## APPLICATION FOR LISTED BUILDING CONSENT OFFICER DELGATED REPORT

| <b>APPLICATION REFERENCE:</b> | PL/2026/03066                                                                            |
| <b>SITE ADDRESS:</b>          | 24 High Street, Warminster, BA12 9AF                                                     |
| <b>DESCRIPTION OF WORKS:</b>  | Replace 4No. wooden sash windows with new UPVC sash windows first floor and second floor |

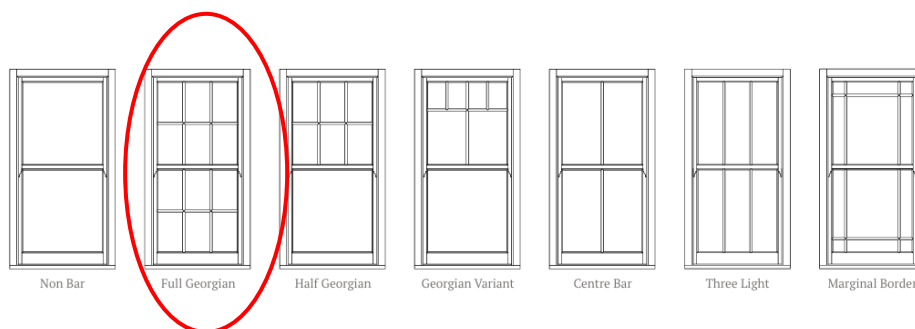
The application is for the replacement of 4 windows (sashes and boxes) on the southern and eastern elevations at first and second floor.

The proposed replacement windows would result in the removal of the entire window (sash and boxes) resulting in the loss of historic fabric. The replacement windows would be PVCu ie a non-traditional material with a different character to timber. They would require a spiral balance system resulting in the loss of the traditional lead weight pulley system. The sashes would be a single-pane of glass with applied glazing bars rather than traditional run-through bars, as such, if there is any characterful glass surviving, it could not be used in the new windows and the new windows would lack the animation and reflective qualities of a multi-paned window.

In conclusion, the loss of historic fabric such as window frames, boxes and possibly glazing will therefore inevitably cause harm to the significance of the listed building. The replacement windows would not replicate the traditional detailing of a timber sash window and would introduce details which do not reflect the detailing or character of the existing windows which are considered to make a strong positive contribution to the character and appearance of the listed building.
